PRODUCT CHANGE NOTICE

PCN#13-012NOTIFICATION DATE: **December 31, 2013****MODEL(S) AFFECTED:****Model Series: TC, TCM, TCP, TCD, TCH**See specific model datasheets for links at www.minicircuits.com

Attachment to PCN#13-012

CASE #	A	B	C	D	E	F	G	H	J	K	WT. GRAM
DB714	.160 (4.06)	.150 (3.81)	.160 (4.06)	.050 (1.27)	.040 (1.02)	.025 (0.64)	.028 (0.71)	.065 (1.65)	.190 (4.83)	.030 (0.76)	.15

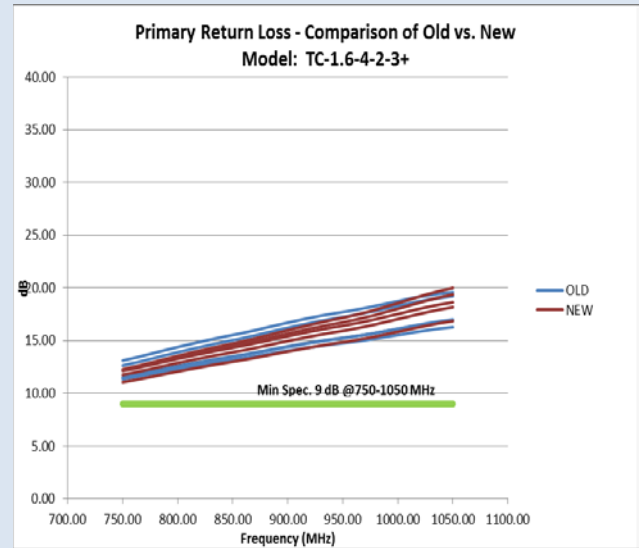
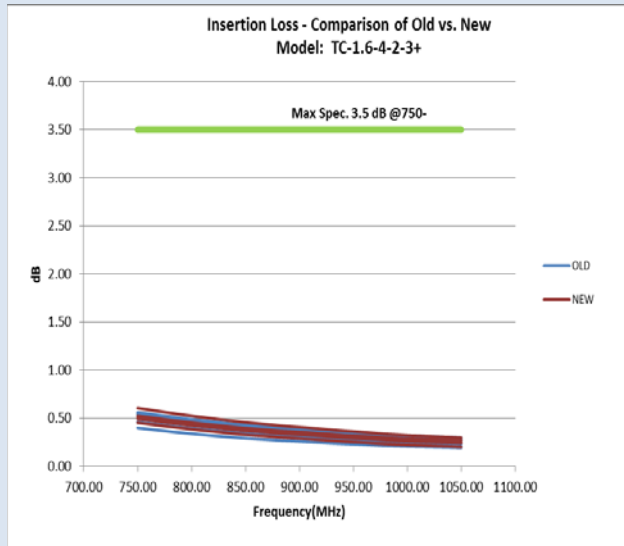
Change of appearance of plastic substrate

- No change in Fit, Form or Function
- Slight change in appearance of the substrate
